Access Compliance Report

Public Rights-of-Way

(Curb Ramps)

Intersection ID: 27717	Main Street: HEADFORD_RD	Cross Street: LEINSTER_DR	Location: SE
ADA ID: CB2D65420A36	Ramp Type: BlendTrans1	Initial Pass/Fail: Fail	Overall Compliance: No
			Severity Score: 36.25

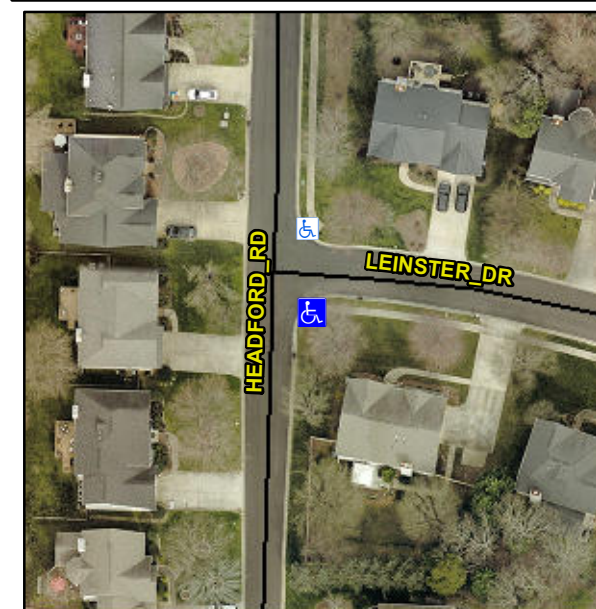
Not Found, R304.5.1, R304.5.3

Compliance	Description	Data	Compliance	Description	Data
N/A	Ramp Length (in)	93.0	Yes	BlendTrans Slope (%)	4.8
No	Ramp Width (in)	31.0	No	BlendTrans XSlope (%)	2.8
N/A	Flare Type LT	N/A	N/A	Flare Type RT	N/A
N/A	Flare Slope LT (%)	N/A	N/A	Flare Slope RT (%)	N/A
N/A	Flare Traversable LT?	N/A	N/A	Flare Traversable RT?	N/A
N/A	Landing Length (in)	N/A	N/A	DWS Provided?	N/A
N/A	Landing Width (in)	N/A	N/A	DWS Contrast?	N/A
N/A	Landing Slope (%)	N/A	N/A	DWS Length (in)	N/A
N/A	Landing X Slope (%)	N/A	N/A	DWS Full Width?	N/A
N/A	Landing Curb? (Y/N)	N/A	N/A	DWS Offset (in)	N/A
N/A	Shared Landing?	N/A			
N/A	Gutter Ponding?	N/A	N/A	Gutter Slope (%)	N/A
N/A	Gutter Lip Ht (in)	N/A	N/A	Gutter X Slope (%)	N/A
N/A	Painted X Walk1?	No	N/A	Painted X Walk2?	No
	X Walk 1 Direction	To N		X Walk 2 Direction	To W
	X Walk 1 Width (in)	N/A		X Walk 2 Width (in)	N/A
	X Walk 1 Slope (%)	0.6		X Walk 2 Slope (%)	1.0
	X Walk 1 X Slope (%)	0.9		X Walk 2 X Slope (%)	2.1

N/A	Ramp inside XWalk1?	N/A	N/A	Ramp inside XWalk2?	N/A
	Road Slope (%)	0.5		Clear Space?	N/A
	Road X Slope (%)	2.0	N/A	Clear Space to XWalk (in)	N/A
N/A	Any Obstructions?	N/A	N/A	Storm Grate/Utility Hazard?	N/A
	Obstruction Type			Storm Grate/Utility Type	
		N/A			N/A
			Yes	Surface Condition? (G/P)	Good
			No	Curb Slope (%)	16.1

Remove & Replace Curb Ramp With Two New Directional Ramps or Equivalent.
